Outer Dowsing Offshore Wind

Schedule of Changes for Plans

Document Reference: 2.0 Revision: 3.0

Appendix 1 Changes to Order Limits, Response to Section 51 Advice, 31

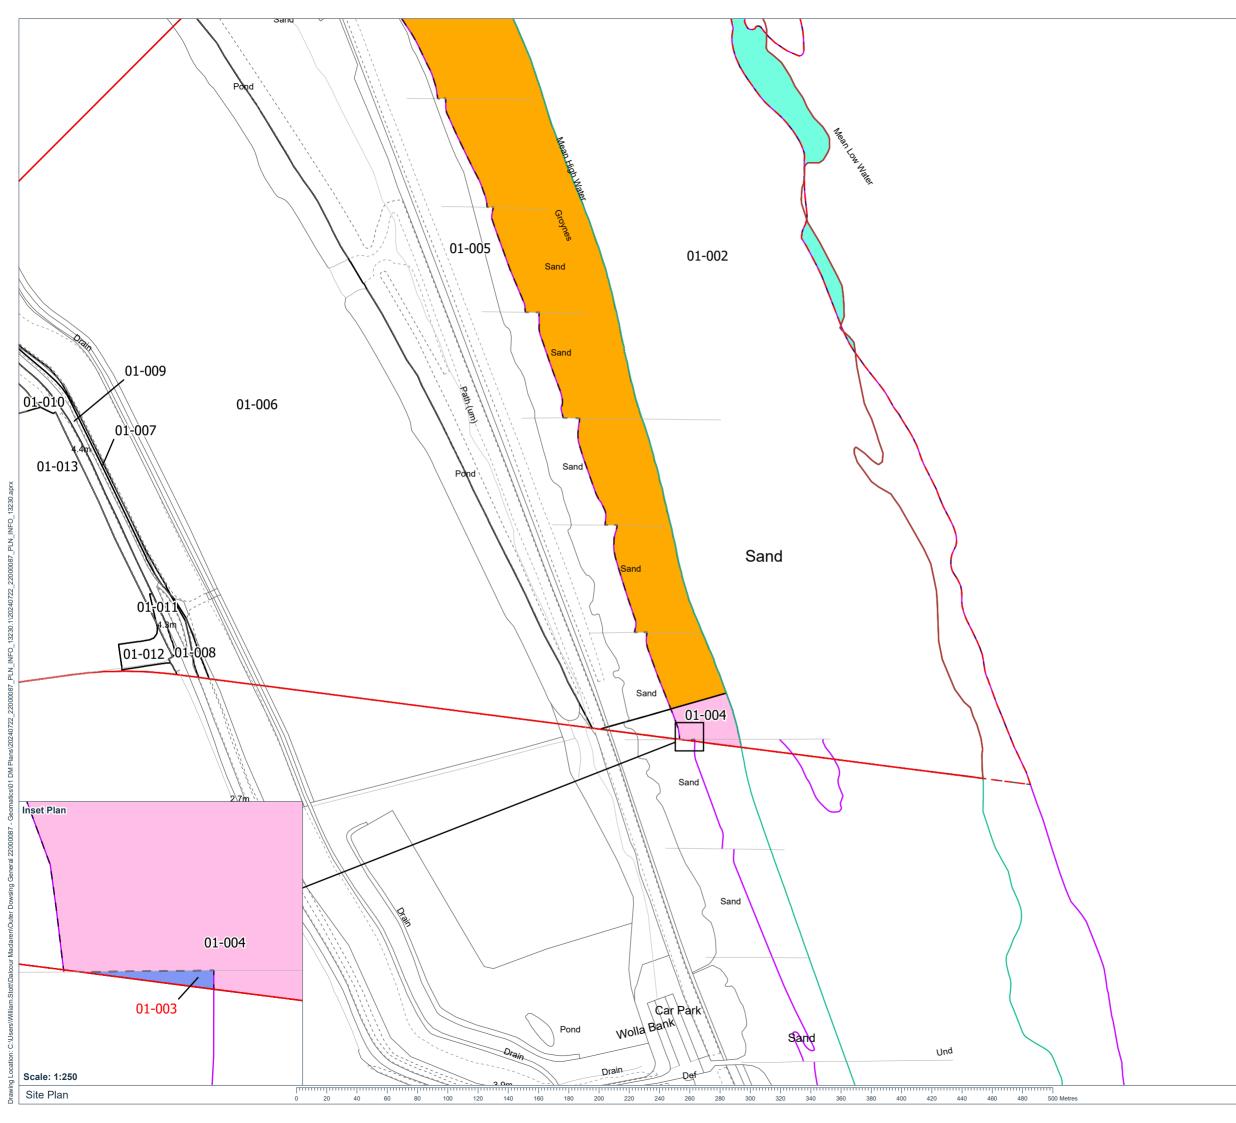
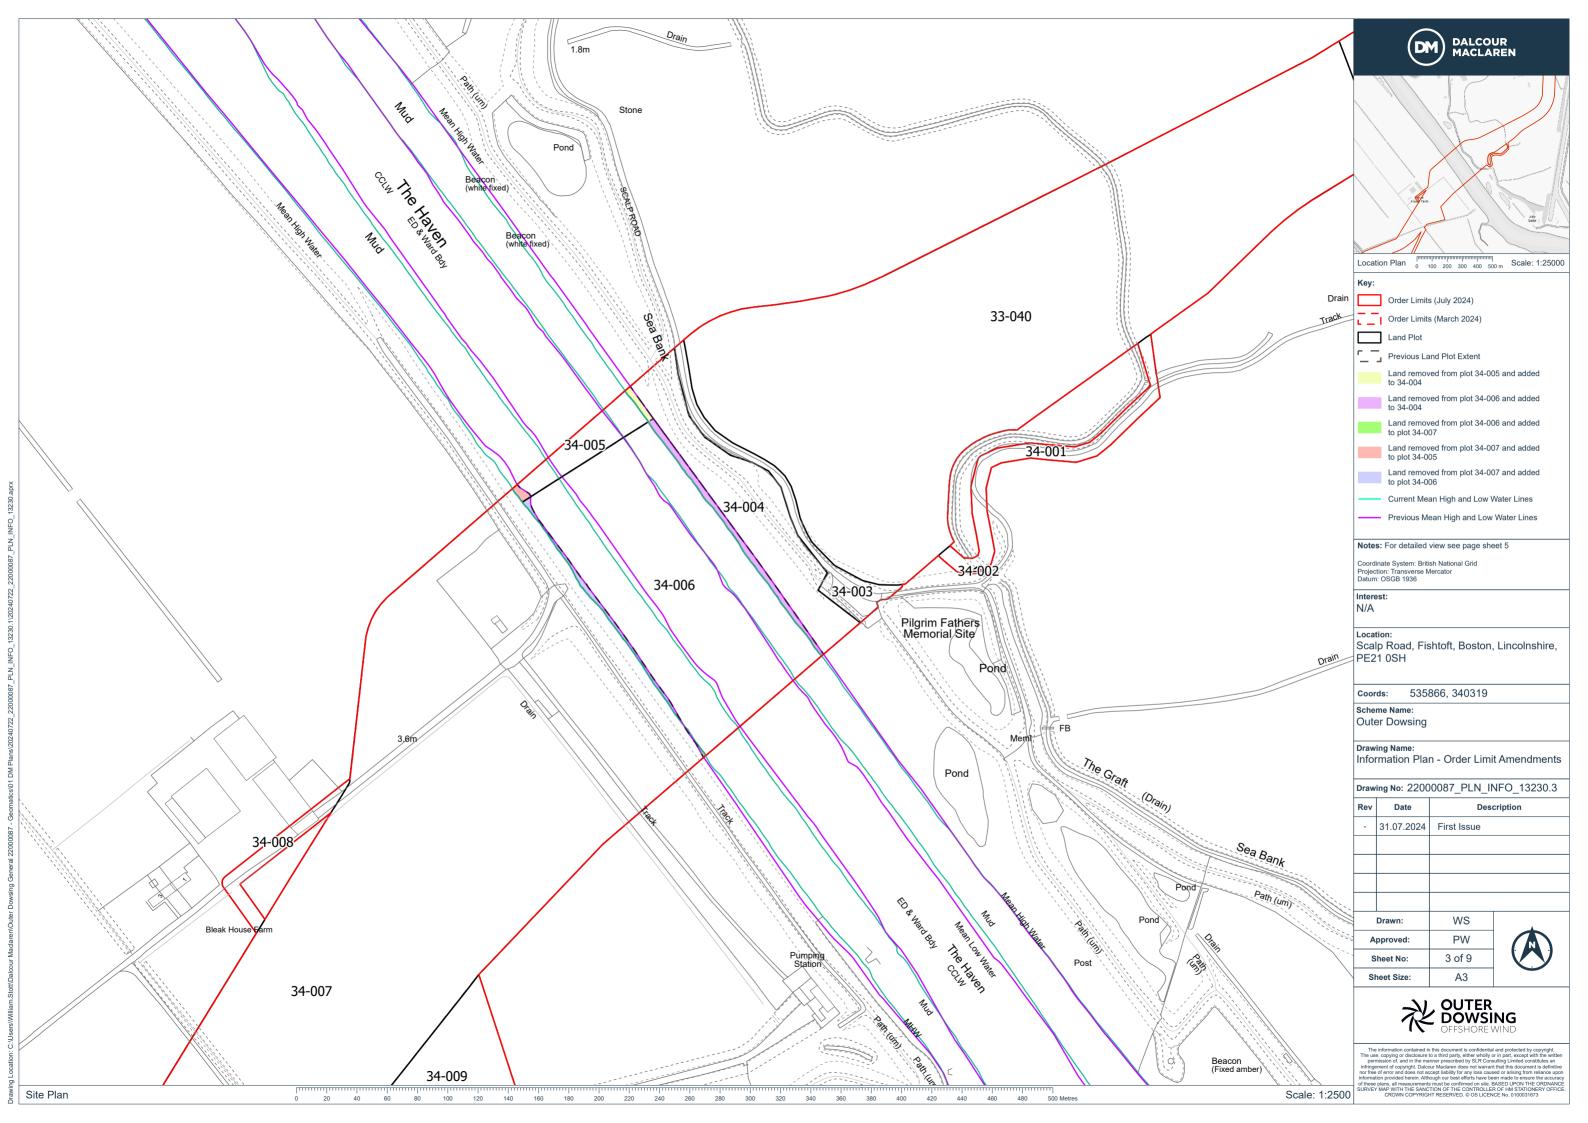
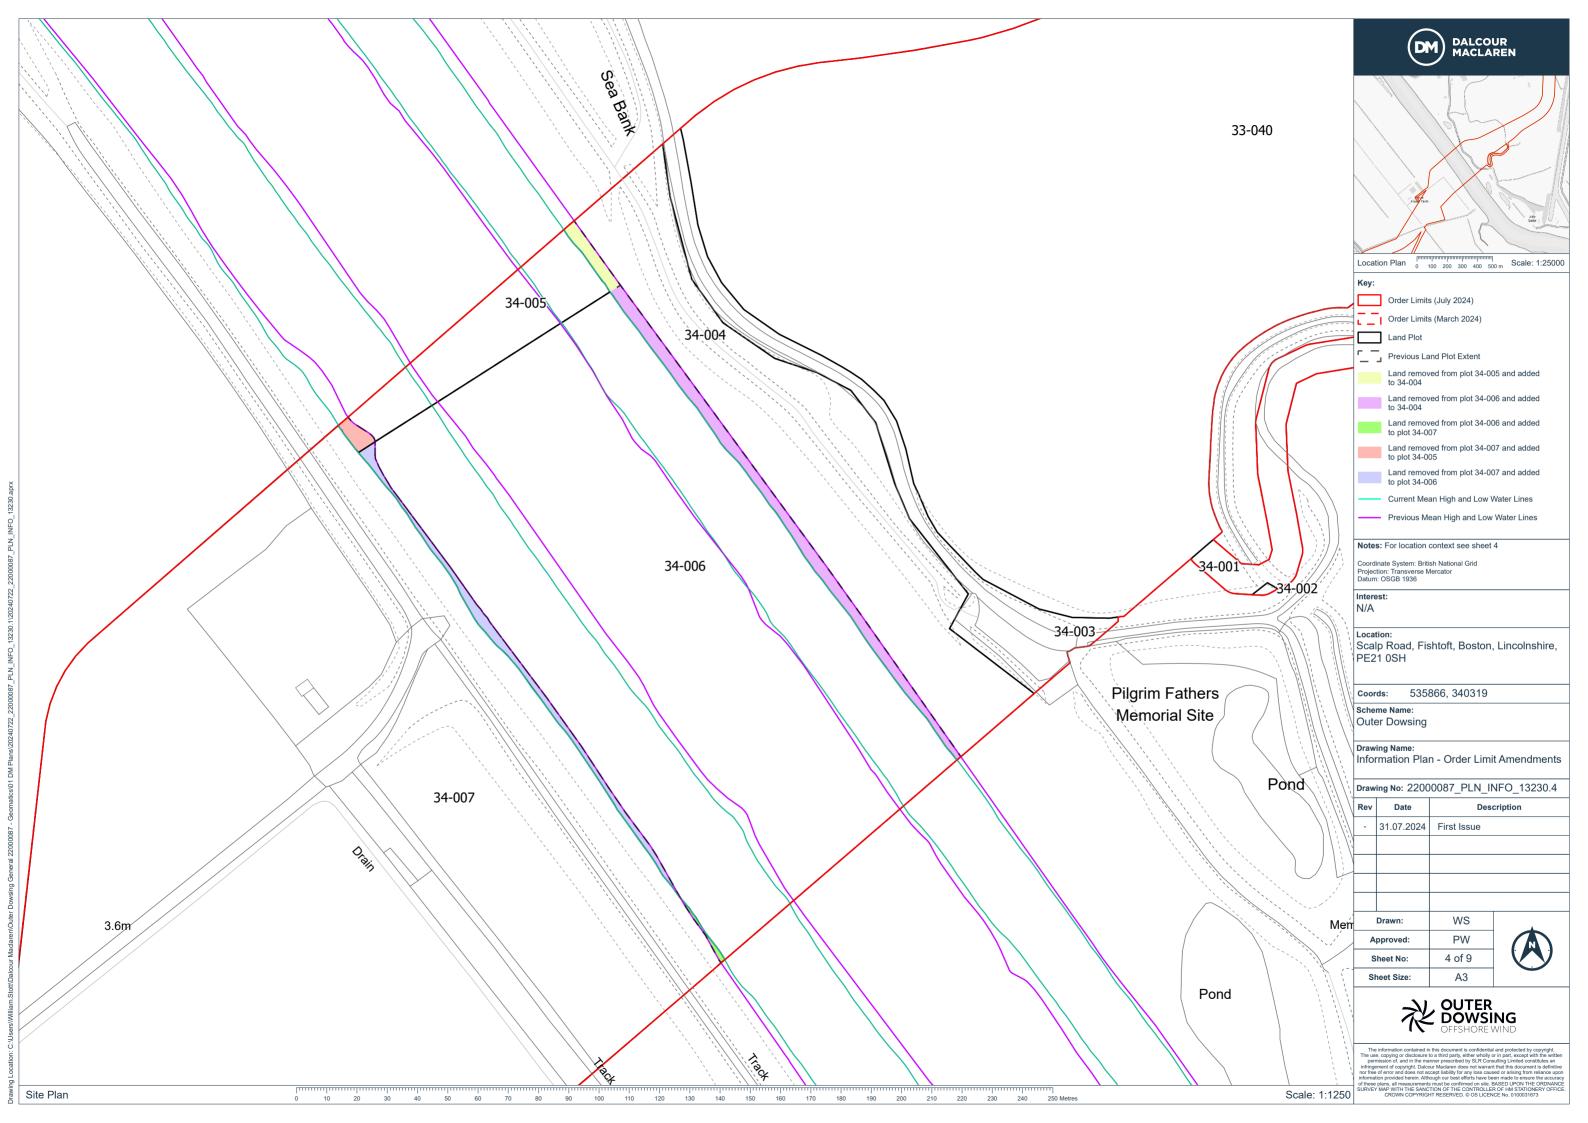
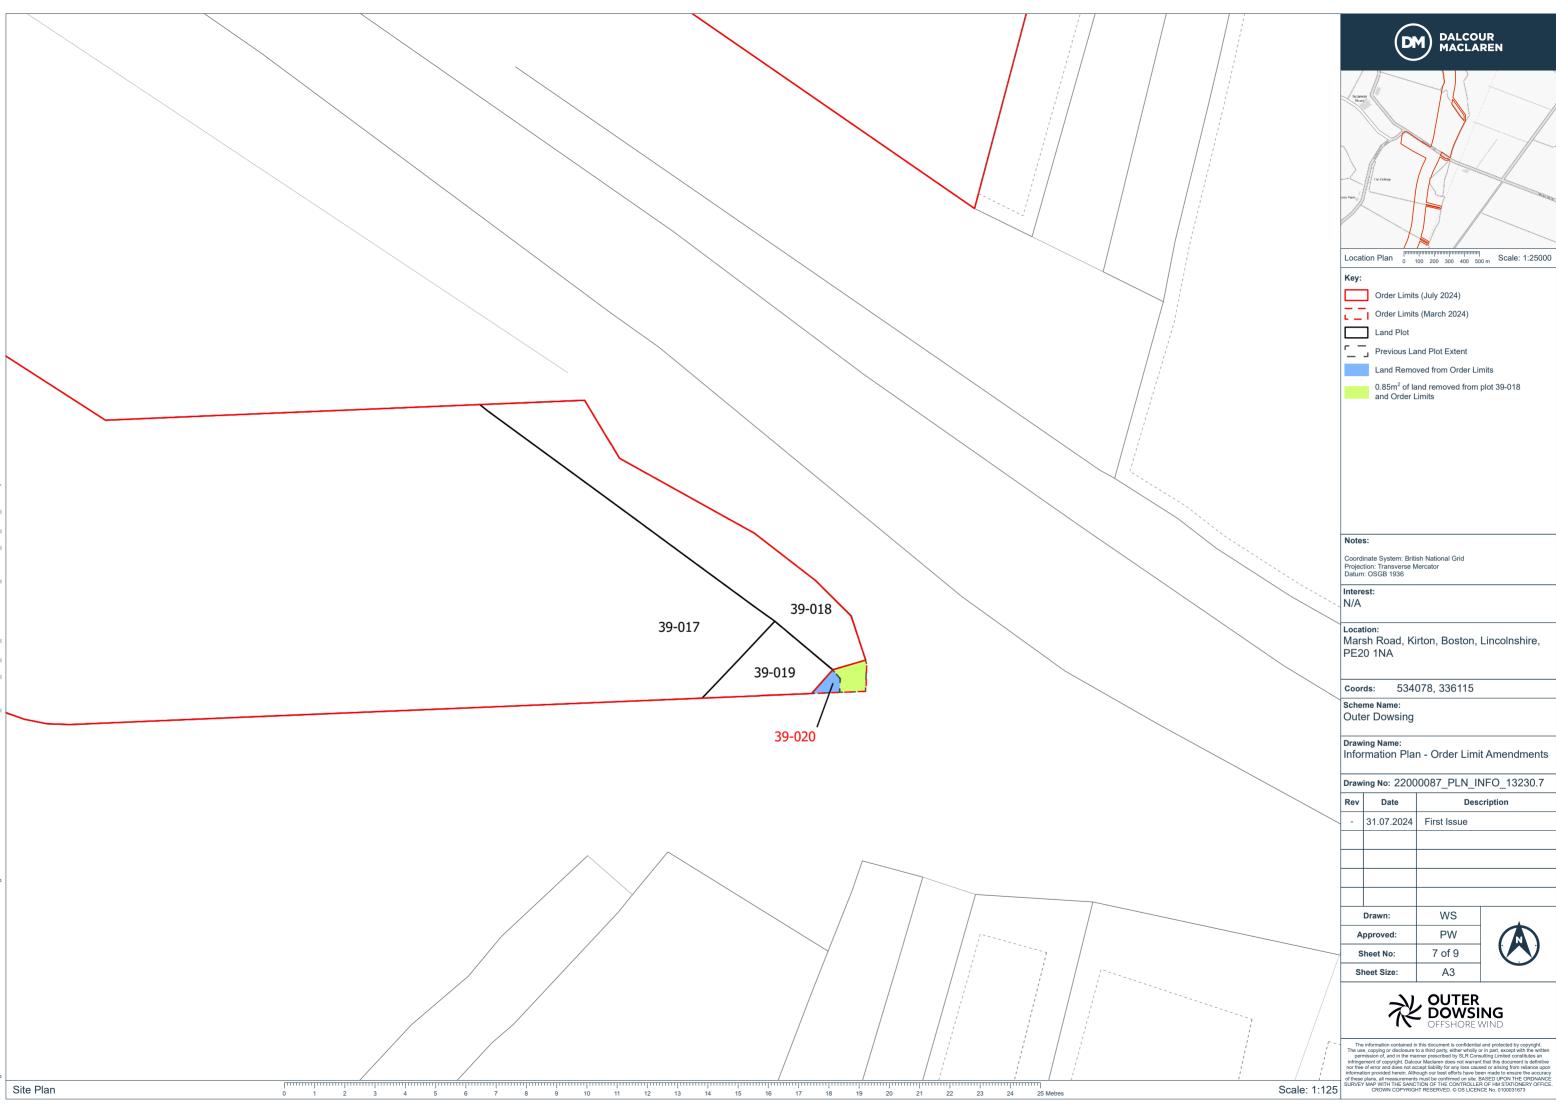
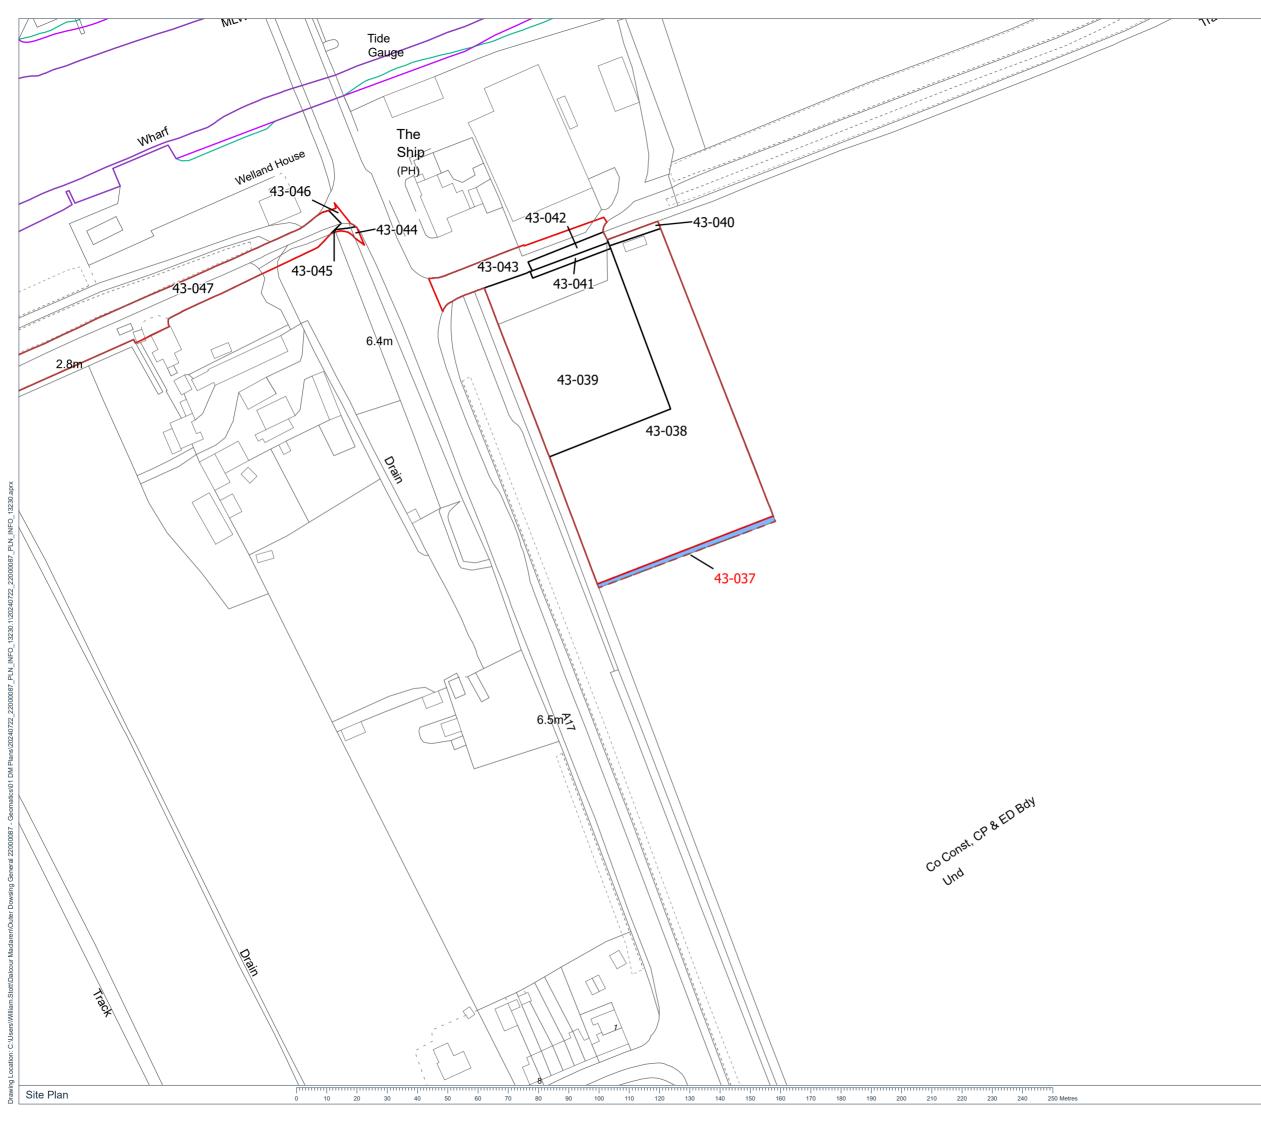
- 10. All onshore plans have been updated to reflect further minor onshore Order Limit reductions as a result of ongoing design refinement and works to refine land plots, which resulted in the removal of unnecessary plots associated with Temporary Works Areas/Compounds, and enabling access routes. These refinements result in no changes to assessment conclusions presented in the Application and are shown in Appendix 1 Changes to Order Limits, Response to Section 51 Advice, 31 July.
